Community Open House Summary - 2018 September 19

**PROPOSED REDESIGNATION OF
1703, 1707 & 1711 - 47 STREET SW**

WESTGATE MIXED USE DEVELOPMENT OPEN HOUSE - SEPTEMBER 19, 2018, 7PM

SUMMARY OF POSTED COMMENTS, VERBATIM

SHADOW STUDY

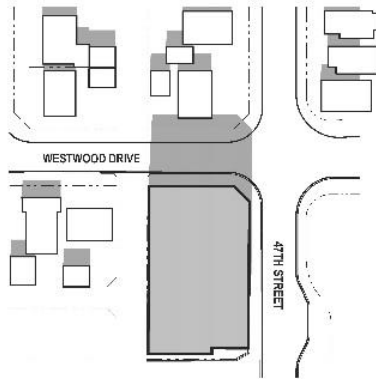
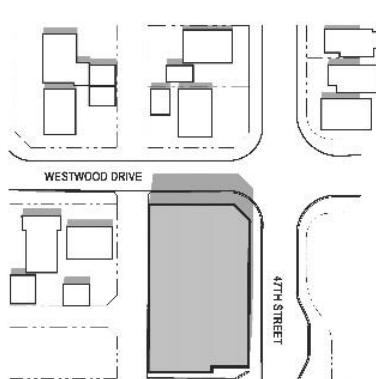
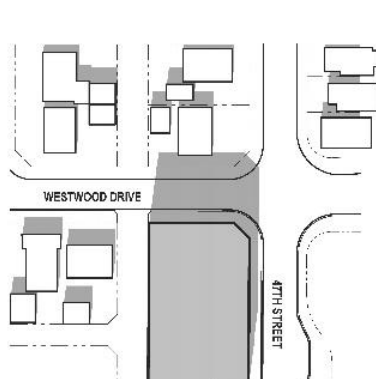
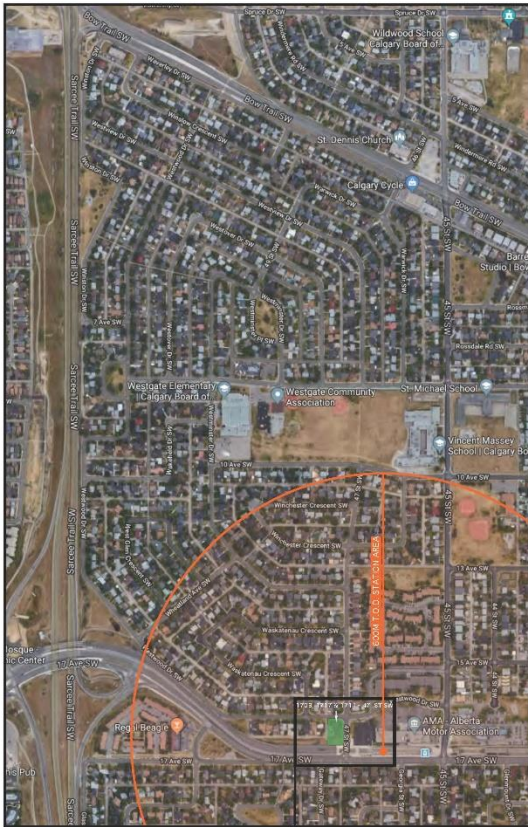
"Mixed Residential is not viable. Parking is already an issue. 3 Story Residential only would be fine with underground parking."
"Love the retail - no office - 3 floors of res."
"We feel a 3 storey building would be appropriate. Higher would create long shadows in winter months (Why was DEC. 21 not shown in shadow study)."
"General design is pleasing, but looks like we're trying to fit the biggest bldg possible. How about some breathing room? Green space?"
"Zone for 4 storeys only!!! 100% parking!!!"
"No office building"
"Residential housing no commercial office"
"We'd like to see condo not rented apartments"
"Keep this community more family orientated. Don't build 5 story small units - do 3 story larger family units"
"Residential only Please! Need retail, take the train!"
"Make it housing only. 3 storey."
"How about a row of townhomes?"

"I feel we (residents) paid a higher \$\$ to live here. Little traffic and not much rental, retail ect. Please look elsewhere"
QUESTIONS
"42 spots - "relaxed parking" what is "non-relaxed"?"
"How about affordable housing like in Wildwood"
"Has there been any consideration around increased crime where retail stores and the LRT are side-by-side?"
"If the "R rating" changes it will allow others to build multi use buildings"
"What will the noise levels be from the LRT?"
"How have you determined "minimal impact" as per "Why Westgate?" poster?"
"There is already denisfication from Westwinds Terrace. Why not build by Walmart?"
"This looks to big. How many lots are you taking?"
"Dec 21 shadow?"
"How do you plan to handle/control traffic of construction vehicles & worker/trades traffic."
